**UNITED NUCLEAR
CORPORATION
CHEMICALS DIVISION**

SUBJECT: APPLICATION FOR SOURCE AND SPECIAL NUCLEAR MATERIAL LICENSES
FOR UNITED NUCLEAR CORPORATION'S SCRAP PLANT FACILITIES AT
WOOD RIVER JUNCTION, RHODE ISLAND

This is to supplement our letter of January 31, 1964 and complete
the replies to points mentioned in your letter of January 22, 1964.

DOCKET NO. 70-820

Figure 1

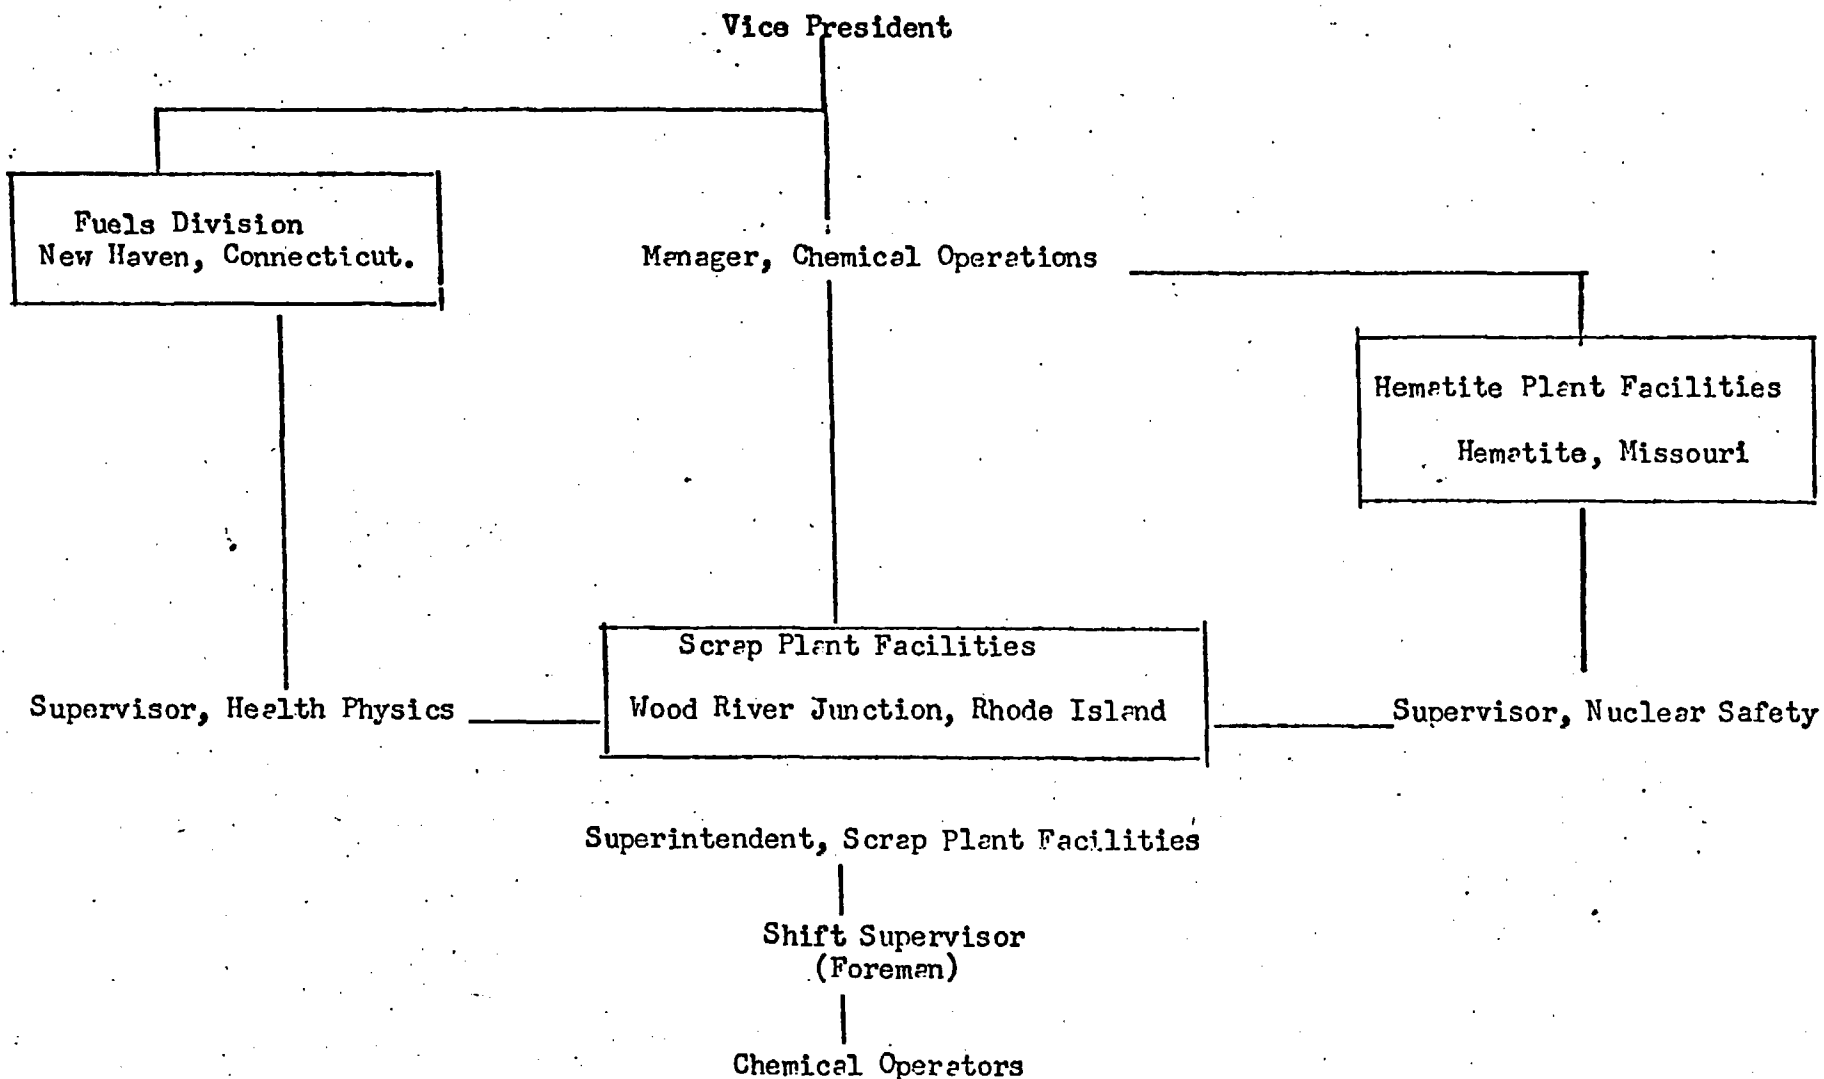
The general organizational structure of the Chemical Operations is shown on Figure 1.
